**Draft Findings of Fact  
153 Park Row  
Request for Certificate of Appropriateness for Structural Alteration  
Village Review Board  
Review Date: August 19, 2014**

**Project Name:** Replacement of Window with Door (after the fact)

**Case Number:** VRB -14-028

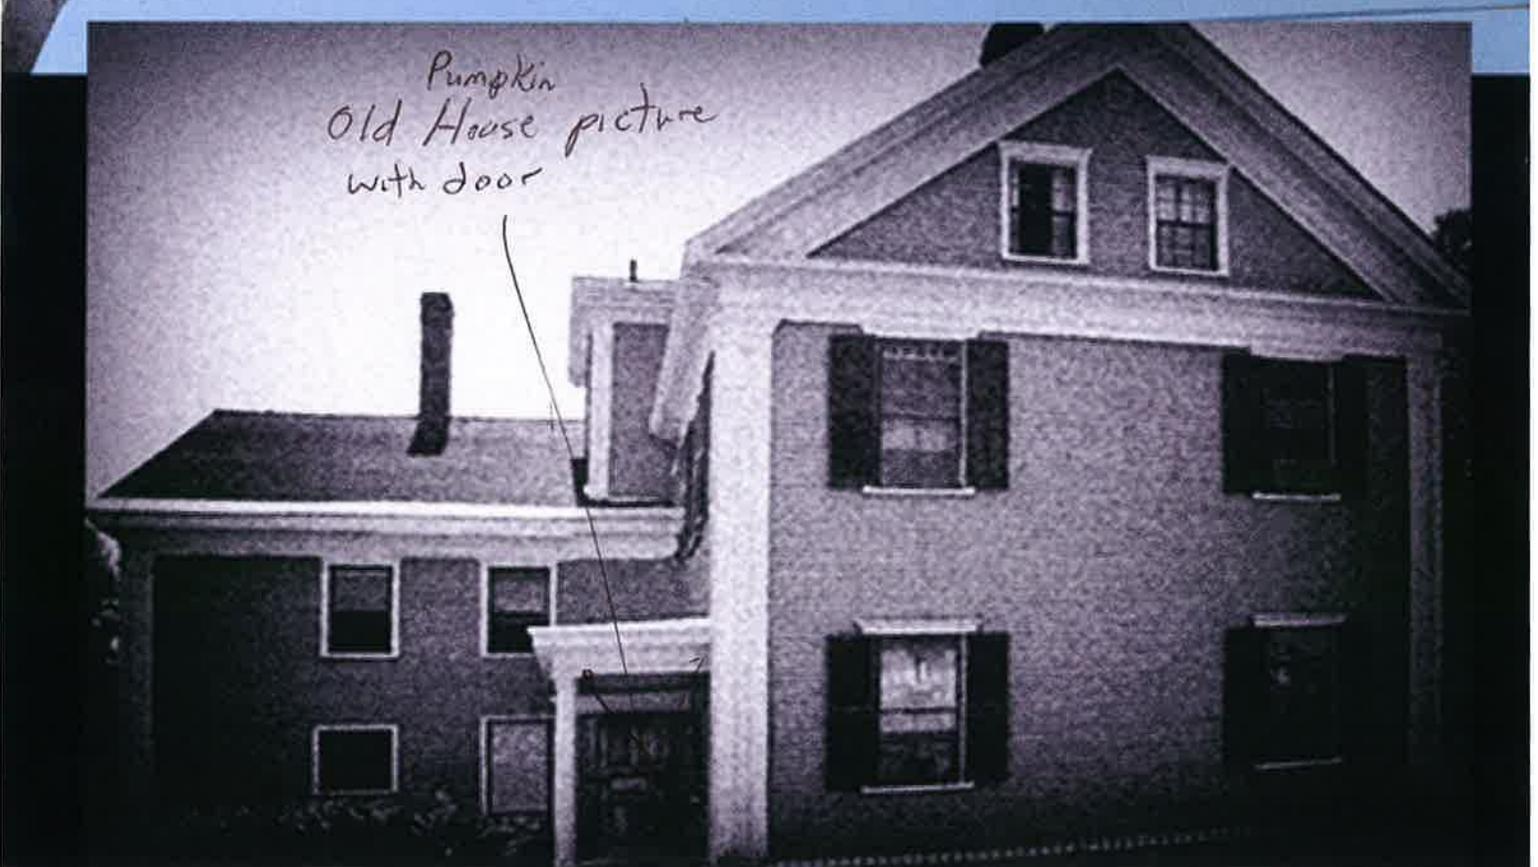
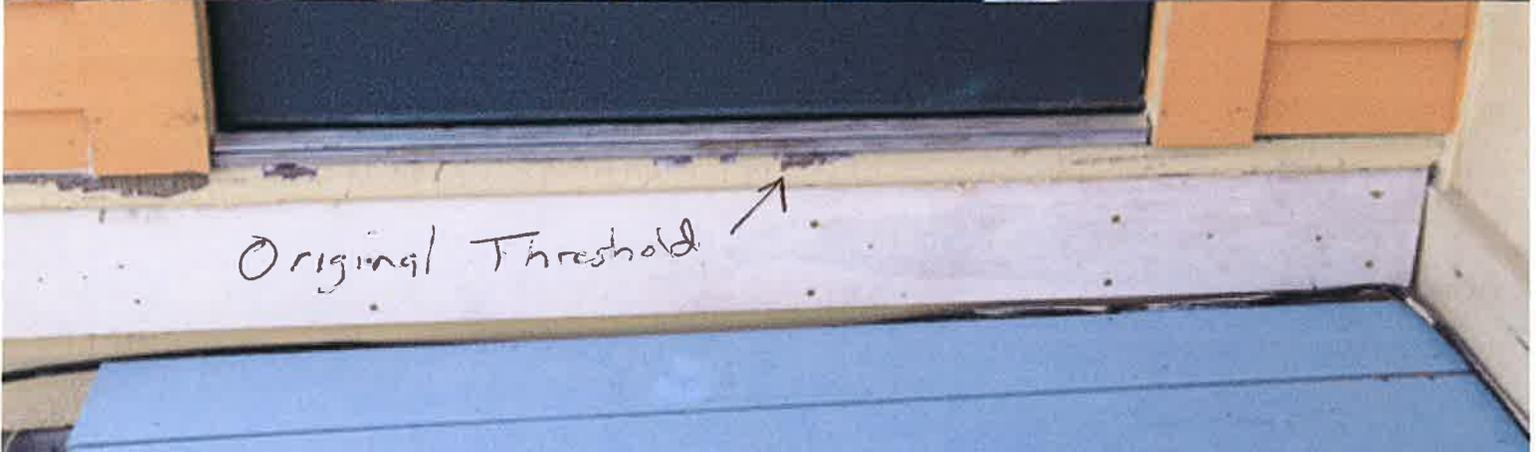
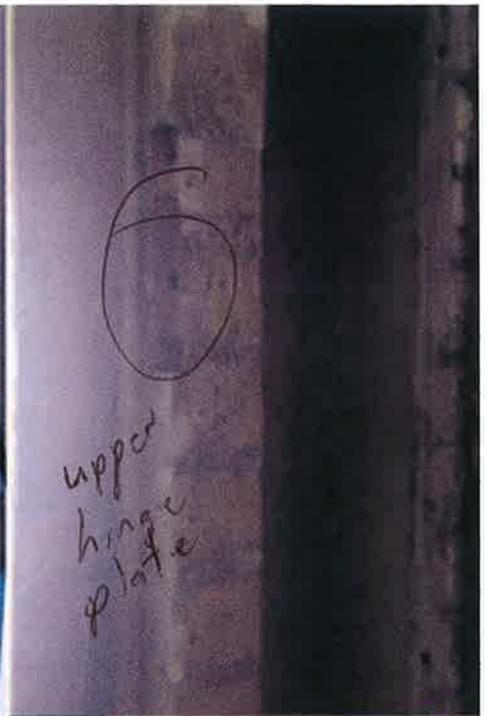
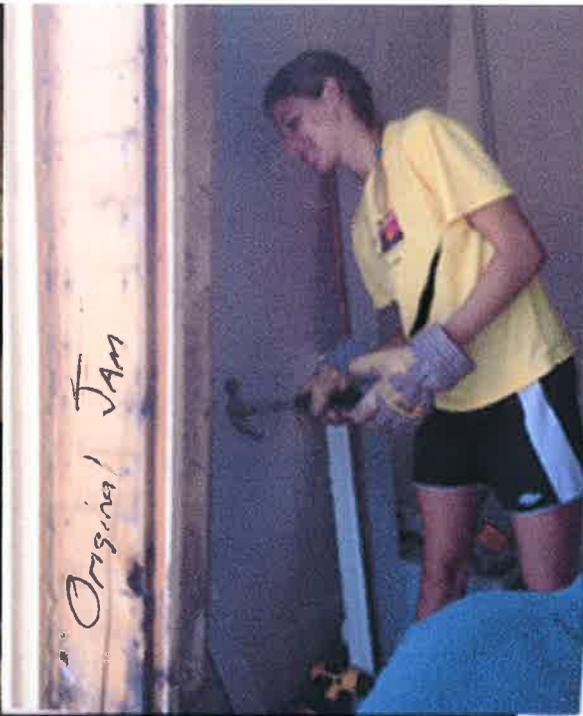
*existing window trim. The applicant has provided evidence that an earlier entry door had been replaced by the window now removed for the door as original designed. A step has been added to the side porch to access the building. The original door opening/trim was modified for the window first, now modified again for a new door. No other changes have been made. Photos of completed alterations are attached.*

- a. Any additions or alterations shall be designed in a manner to minimize the overall effect on the historic integrity of the contributing resource.** *As documented by the applicant the replaced door reestablishes an original condition of the historic structure. However, the above door trim work is a “remnant” of the existing window trim and is not compatible with the rest of the door trim.*

- c. Concealing of distinctive historic or architectural character-defining features is prohibited. If needed, the applicant may replace any significant features with in-kind replacement and/or accurate reproductions.** *The original door jamb was already replaced by the existing window. The new door, although now narrower in width, is an acceptable replacement.*

1. That the Board's review and approval does hereby refer to these findings of fact, the plans and materials submitted by the applicant and the written and oral comments of the applicant, his representatives, reviewing officials, and members of the public as reflected in the public record. Any changes to the approved plan not called for in these conditions of approval or otherwise approved by the Director of Planning and Development as a minor modification, shall require further review and approval in accordance with the Brunswick Zoning Ordinance.
2. That the trim work above the doorway be replaced with one fitting the size of the new entryway, compatible with the remaining door trim.
